Southern Nuclear Operating Company
Vogtle Electric Generating Plant Units 3 and 4
Supplement to Request for License Amendment and Exemption:
Radiologically Controlled Area Ventilation System (VAS) Design Changes (LAR-15-011S1)

Response to NRC Staff Comments Regarding the LAR-15-011 Review

Supplement to Proposed Changes to Licensing Basis Documents

UFSAR Figure 9.4.3-1 (Sheet 2 of 3) Radiologically Controlled Area Ventilation System Piping and Instrumentation Diagram (REF) VAS 003 & 010

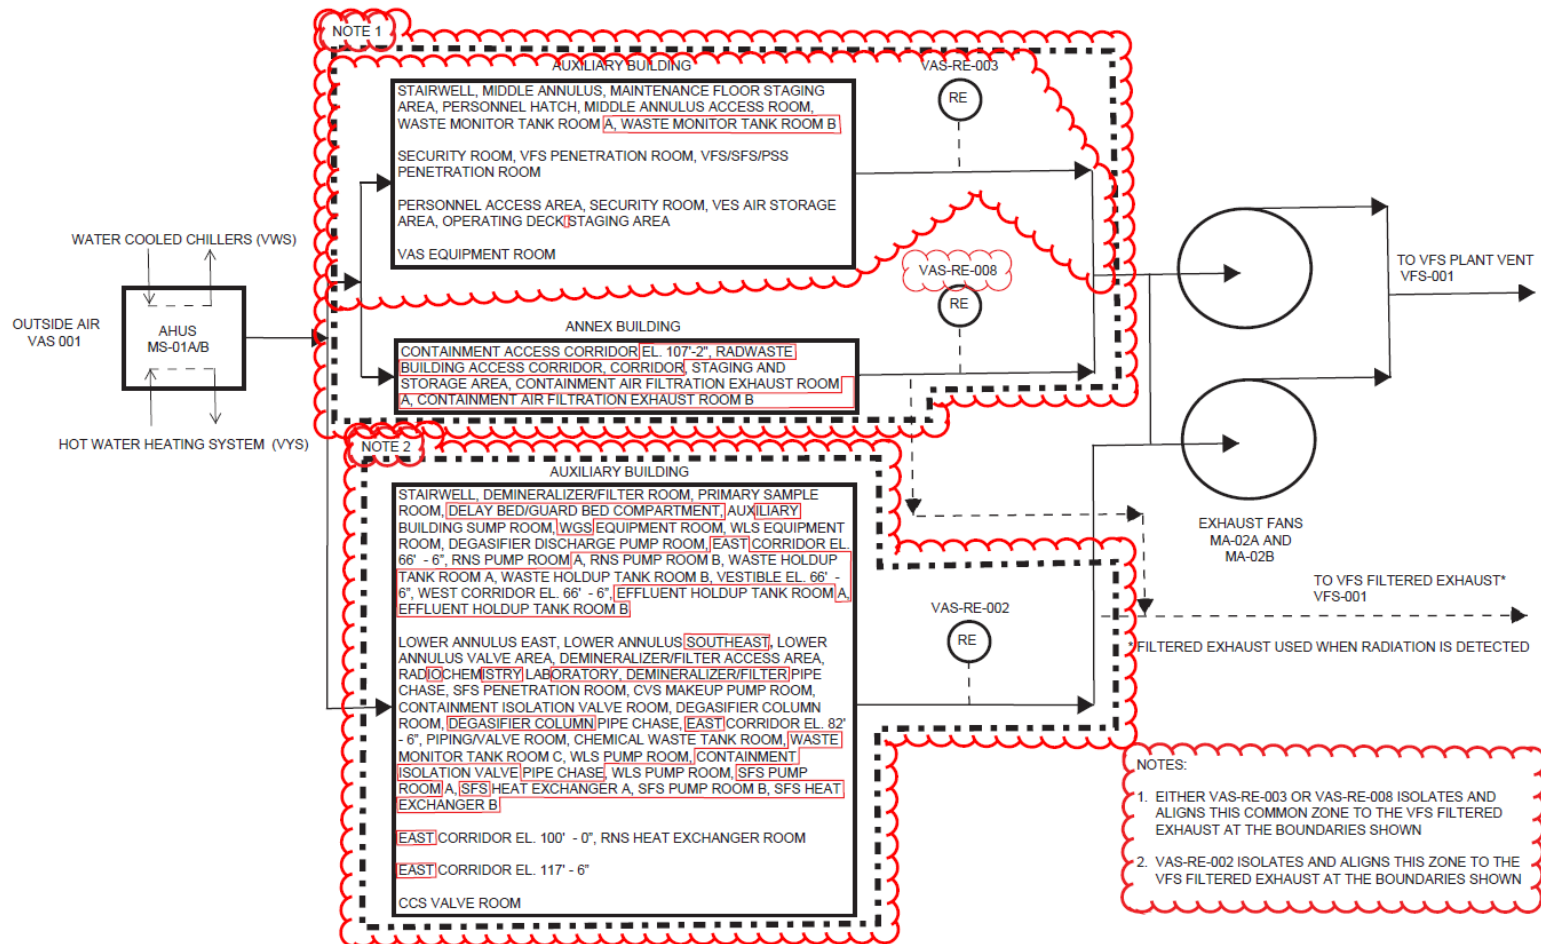
1. LAR 15-15 [SNC LAR-15-011] contains proposed revisions to UFSAR Figure 9.4.3-1 (Sheet 2 of 3), which include the addition of airborne radiation detector VAS-RE-008 to monitor the exhaust flow from the annex building.

- a. This figure shows dashed lines coming from the exhaust ducting coming from both the annex building (monitored by radiation detector VAS-JE-RE008) and from the portion of the auxiliary building indicated on the lower portion of the figure (monitored by radiation detector VAS-JE-RE002). These dashed lines indicate that a filtered exhaust flowpath is used when radiation in the exhaust ducts is detected. If radiation detector VAS-JE-RE003, which monitors the air coming from the portion of the auxiliary building indicated on the upper portion of Figure 9.4.3-1, is also able to isolate this zone and direct the airflow from this portion of the auxiliary building to the filtered flowpath, then this capability should be clarified on UFSAR Figure 9.4.3-1 (Sheet 2 of 3).

- b. UFSAR Figure 9.4.3-1 (Sheet 2 of 3) shows that the filtered exhaust flowpath line for the annex building and portion of the auxiliary building ties into the exhaust ducting from the annex building upstream of radiation detector VAS-JE-RE008. If high airborne radioactivity from the annex building is detected in the exhaust duct from this zone by radiation detector VAS-JE-RE008, this detector will close the supply and exhaust duct isolation dampers for the annex and auxiliary (upper portion shown on this figure) buildings and reroute this air through the filtered exhaust flowpath shown. In this situation, the exhaust air coming from the portion of the auxiliary building monitored by radiation detector VAS-JE-RE003 will flow past radiation detector VAS-JE-RE003, as well as past radiation detector VAS-JE-RE008, before being routed through the filtered exhaust flowpath line to the containment air filtration exhaust units. If the exhaust air coming from the auxiliary building does not contain high airborne radioactivity, the passage of this uncontaminated air past radiation detector VAS-JE-RE008 could result in the radiation readings from this detector decreasing. Since the readings from radiation detector VAS-JE-RE008 are monitored by operators in the control room, this decrease in the radiation levels measured by this detector could result in some uncertainty regarding the actual radiation levels of the air being exhausted from the annex building.

UFSAR Figure 9.4.3-1 (sheet 2 of 3) shows that the filtered exhaust flowpath line to the containment air filtration exhaust units for the exhaust air from the portion of the auxiliary building being monitored by radiation detector VAS-JE-RE002 is located downstream of this detector. If the filtered exhaust flowpath line that ties into the exhaust duct from the annex building were to be relocated so that it is downstream of radiation detector VAS-JE-RE008, then this modification would resolve the issue described in the previous paragraph regarding potential misleading readings from radiation detector VAS-JE-RE008 under certain

conditions. Locating radiation detector VAS-JE-RE008 upstream of the filtered exhaust flowpath instead of downstream of the filtered flowpath would also ensure that you would have an accurate indication of the activity of the air from the annex building that is being directed through the filtered exhaust flowpath.

On the basis of the reasons discussed above, justify your reasons for not relocating this filtered exhaust flowpath so that it is located downstream of radiation detector VAS-JE-RE008.

- a. As described in LAR-15-011, Enclosure 1, Subsection 2.1, the proposed auxiliary building exhaust radiation detector VAS-JE-RE003 monitors a portion of the auxiliary building areas, as shown in the top box of proposed UFSAR Figure 9.4.3-1 (Sheet 2 of 3), and retains its current functions to alarm in the control room, to automatically isolate the zone (UFSAR Subsection 9.4.3.2.1.1), and automatically to start the containment air filtration system when high airborne radioactivity in the exhaust air duct is detected (UFSAR Subsection 9.4.3.2.3.1). In addition, Subsection 2.2 states that the new annex building exhaust radiation detector VAS-JE-RE008 acquires the function to monitor the annex building areas, as shown in the middle box of proposed UFSAR Figure 9.4.3-1 (Sheet 2 of 3), to alarm in the control room, to automatically isolate the associated zone (UFSAR Subsection 9.4.3.2.1.1), and to automatically start the containment air filtration system when high airborne radioactivity in the exhaust air duct is detected (UFSAR Subsection 9.4.3.2.3.1). These areas are a part of a single common associated zone, and the signal to isolate the common normal air supply and exhaust dampers, and to then open the common filtered exhaust damper to the VFS filtered exhaust, is provided from either the renamed and relocated auxiliary building exhaust radiation detector VAS-JE-RE003 or the new annex building exhaust radiation detector VAS-JE-RE008. Therefore, this zone continues to include both the remaining auxiliary building areas not monitored by

auxiliary building exhaust radiation detector VAS-JE-RE002, and the annex building areas; these combined areas are isolated and the exhaust is routed to the VFS filtered exhaust as shown by the dashed line shown on UFSAR Figure 9.4.3-1 (Sheet 2 of 3) upstream of the new annex building exhaust radiation detector VAS-JE-RE008.

Therefore, UFSAR Figure 9.4.3-1 (Sheet 2 of 3) is proposed to be revised to show the two separate zones as follows:

- i. The upper two areas containing the auxiliary building areas shown in the upper box of the figure and the annex building areas shown in the middle box of the figure will be shown included in one zone, with the boundaries of this common zone identified. A Note 1 is added for this common zone monitored by proposed auxiliary building exhaust radiation detector VAS-JE-RE003 and the new annex building exhaust radiation detector VAS-JE-RE008 to state: "Either VAS-RE-003 or VAS-RE-008 isolates and aligns this common zone to the VFS filtered exhaust at the boundaries shown."

- ii. The remaining auxiliary building areas shown in the lower box of the figure will be shown as included in the other zone, with the boundaries of this zone identified. A Note 2 is added for this zone monitored by auxiliary building exhaust radiation detector VAS-JE-RE002 to state: "VAS-RE-002 isolates and aligns this zone to the VFS filtered exhaust at the boundaries shown."

See page 2 of Enclosure 5 for the proposed revision to UFSAR Figure 9.4.3-1 (Sheet 2 of 3).

- b. When high airborne radioactivity is detected by either radiation detector VAS-JE-RE003 or VAS-JE-RE008, the direction of the airflow across VAS-JE-RE008 will reverse as the exhaust air is diverted to the VFS filtered exhaust. If the source of the high airborne radioactivity was in the annex building and the reversed flow of air over the radiation detector was then carrying clean air from the auxiliary building, then it would be expected that airborne radioactivity levels detected by VAS-JE-RE008 would decrease. Each radiation detector has a separate alarm in the main control room. Therefore, regardless of what the duct radiation detectors indicate after a high airborne radioactivity signal, abnormal operating procedures developed in accordance with UFSAR Subsection 13.5.2.1 require the operators to notify health physics to perform surveys of the areas monitored by the radiation detector that alarms to determine the source of the high airborne radioactivity that triggered the alarm, and that provided for automatic isolation and VFS filtered exhaust for the affected zone. Plant operators are trained to follow procedures which require the high airborne radioactivity signal from VAS-JE-RE008 and the situation in the annex building to be investigated prior to restoring normal operation of the VAS.

The current position of radiation detector VAS-JE-RE008 allows the operators to more quickly identify the potential areas of the zone to be investigated first by providing two separate alarms for the two areas included in this common zone. If radiation detector VAS-JE-RE008 detects the high airborne radioactivity, and no change is detected by radiation detector VAS-JE-RE003, then the source is the annex building areas shown in the middle box of the proposed UFSAR Figure

9.4.3-1 (Sheet 2 of 3). If radiation detector VAS-JE-RE003 detects the high airborne radioactivity, then the source is the auxiliary building areas shown in the upper box of the proposed UFSAR Figure 9.4.3-1 (Sheet 2 of 3). Therefore, high airborne radioactivity levels detected by both radiation detector VAS-JE-RE003 and radiation detector VAS-JE-RE008 would be expected to remain high if the source is one or more of the auxiliary building areas in this common zone, and normal VAS supply and exhaust operation could not be manually restored by the operator until the high airborne radioactivity signal clears. It should be noted that the annex building areas monitored by radiation detector VAS-JE-RE008 are less likely to be the source of high airborne radioactivity compared to the auxiliary building areas monitored by radiation detector VAS-JE-RE003 where equipment, tanks, and piping that contain larger amounts of radioactive materials exist. Therefore, the current position of radiation detector VAS-JE-RE008 is sufficient.

It is also worth noting that upon a high airborne radioactivity signal from either radiation detector VAS-JE-RE003 or VAS-JE-RE008, the VAS supply and exhaust fan for that zone are automatically stopped. These fans do not restart automatically once the high airborne radioactivity signal has cleared. As previously stated, regardless of what the duct radiation detectors indicate after a high airborne radioactivity signal, abnormal operating procedures developed in accordance with UFSAR Subsection 13.5.2.1 require the operators to notify health physics to perform surveys of the areas monitored by the radiation detector that alarms to determine the source of the high airborne radioactivity that triggered the alarm prior to restarting the supply and exhaust fans for that zone.

Relocating VAS-JE-RE008 upstream of the branch ductwork that directs air to the VFS filtered exhaust is not a viable design option. Doing this would create the need for additional radiation monitoring equipment and alarm and control signals without gaining any benefits to the health and safety of plant personnel or the general public. The configuration of the VAS exhaust ductwork contains branch duct L241 between the current location of VAS-JE-RE008 and the VFS filtered exhaust duct take-off. If VAS-JE-RE008 was moved from its current location, there would not be a radiation detector in the airflow path to detect radiation in the air being exhausted via L241. Therefore, a new radiation detector would then need to be located in this exhaust ductwork in order to monitor all exhaust air. VAS-JE-RE008 is also located a considerable distance from the branch duct that diverts air to the VFS filtered exhaust. Relocating the branch duct so that it is downstream of the current location of VAS-JE-RE008 would require a significant amount of new ductwork and supports to get the exhaust air back to the VFS filtered exhaust. Because there would be no measurable increase in level of safety by moving VAS-JE-RE008, and because it would require substantial rework of the design, the current position of radiation detector VAS-JE-RE008 remains sufficient and need not be moved.

Based on the above clarifications, no changes to the LAR are proposed.

Revise Figure as shown below. This markup replaces page 4 of Enclosure 3 of LAR-15-011.
